## PAVEMENT DESIGN REPORT

**Skyline at Lorson Ranch, Filing No. 1  
El Paso County, Colorado**

**JOB NO. 188710**

**September 8, 2022  
Revised September 27, 2022**

SHEET No.  
**FIG-2.2**

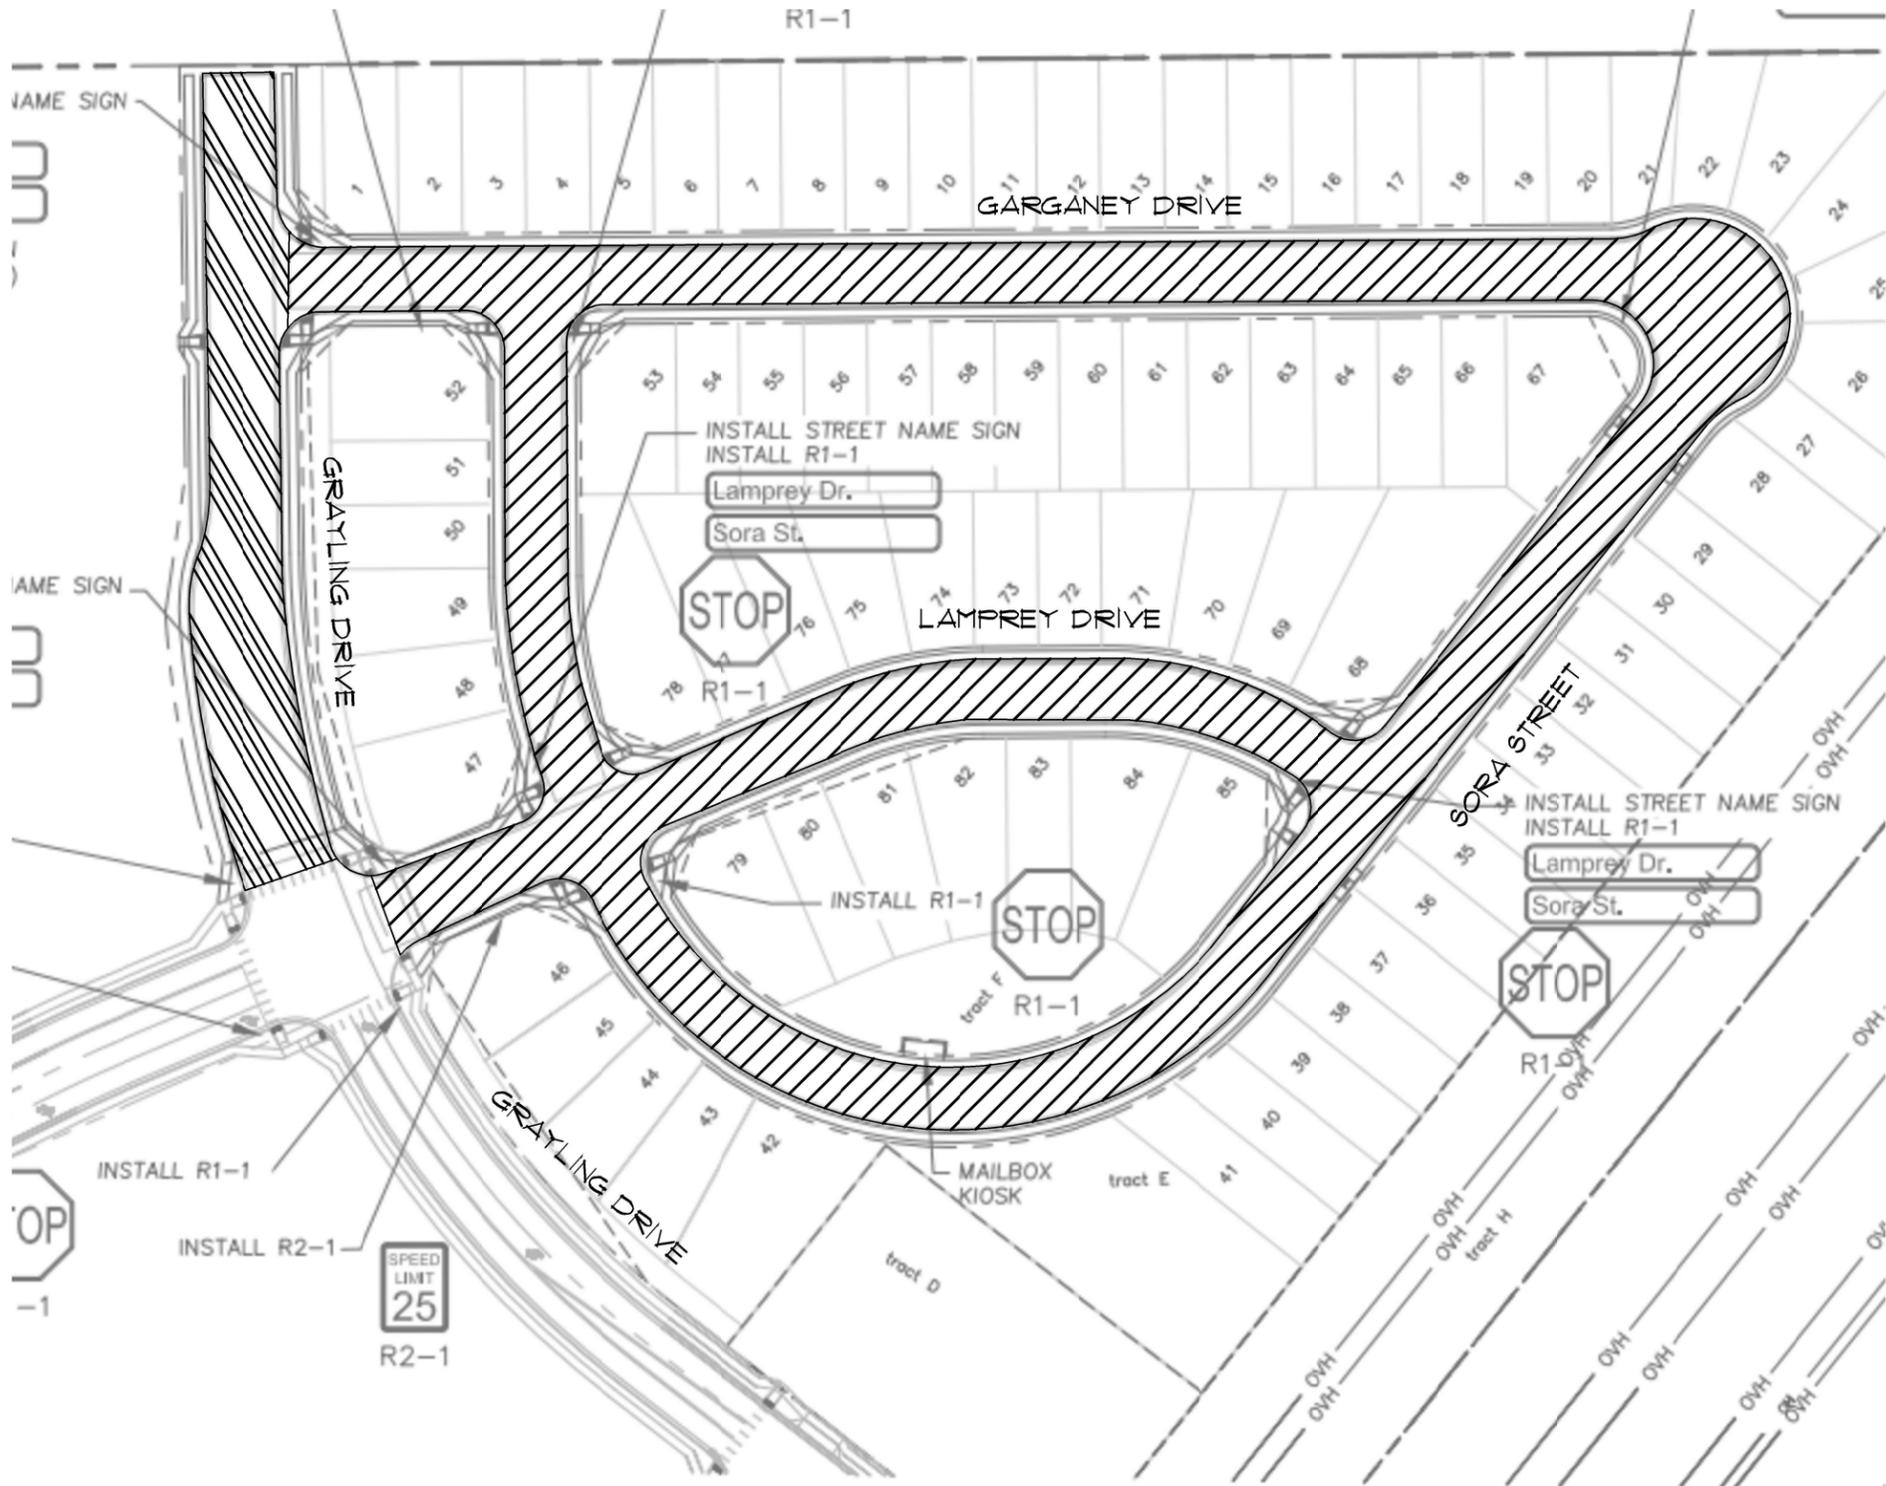
EPC Planning & Community  
Development Department  
Condition: For the Local  
Residential roads, only  
Option 1 may be used.

~~OPTION 2~~  
5" HMA  
OVER  
3.5" ABC

Basecourse thickness exceeds HMA thickness by more than 2.5 times.
